# City of San Antonio

Re: IH 10 & Utex Boulevard – 90 Acre Site

Master Development Plan, **MDP # 042-06**

SHEET  
**C-10**

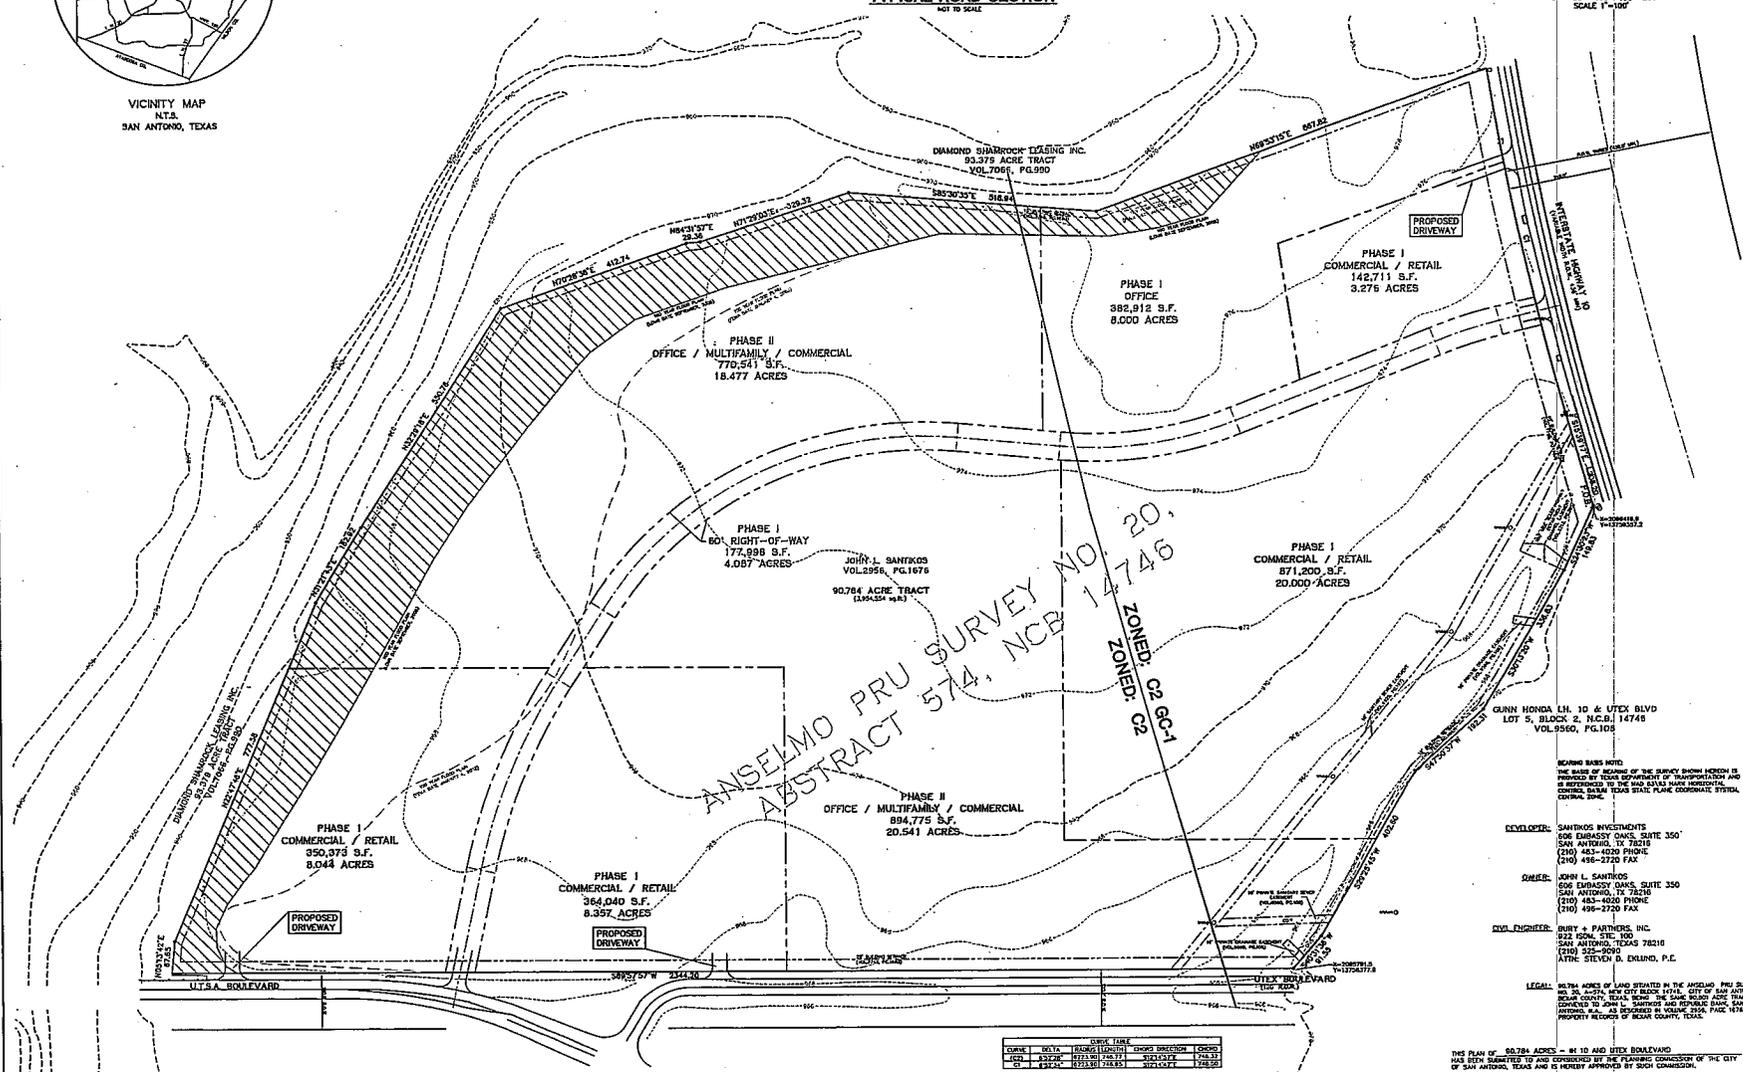
In consideration of public safety and convenience, excessive grades by reason of topography should be avoided in street layouts and arrangements.

The Texas Sites Atlas indicates that archaeological site 41BX597 has been previously identified within the above referenced property. Also, the property may contain other sites, some of which may be significant. Thus, before any work that might affect any sites is begun, we recommend that qualified professionals conduct an archaeological and historical structures investigation of the property

- All roadways shall follow Table 506-7, Functional Classification System Description and shall comply with UDC 35-502(a)(9).

- All access roadways shall provide clear sight distance on all existing and proposed roadways in order to provide adequate obstruction free viewing distances for approaching traffic. All signage, landscaping, and improvements shall be selected and located so as to not block these clear sight distance areas.
- Sidewalks along all interior and exterior roadways are to be installed in accordance with UDC 35-506(q).

**Tree Preservation :** This Master Development Plan meets the criteria of the 2003 Tree Preservation ordinance (Section 35-B125 and Table 35-B101) and is approved.

- 2003 Tree Preservation ordinance standards per UDC Section 35-523 – a Tree Preservation Plan is required prior to any work on site. This can be submitted either as a site work permit, platting or building permit stage.
- Landscape ordinance per UDC Section 35-511. It appears that some landscape points can be met by preserving existing vegetation as well as meeting any mitigation requirements (either through preservation of smaller material or transplanting). Recommend securing knowledgeable Landscape Architect at planning and design phase to better utilize existing trees and vegetation. Preservation will eliminate the need for irrigation. Staff would be willing to meet with developer at design stage to assist with tree preservation and landscape plan.
- Tree preservation and landscaping requirements of the Hill Country Gateway Corridor District.

- If multi-family dwelling units are planned, a parkland dedication plan is submitted to this department at the time of platting.
- All amenities provided shall comply with standards and specifications found in UDC section 35- 503(h) *Credit for Park Facilities* and Table 503-4 if any credit is to be awarded.
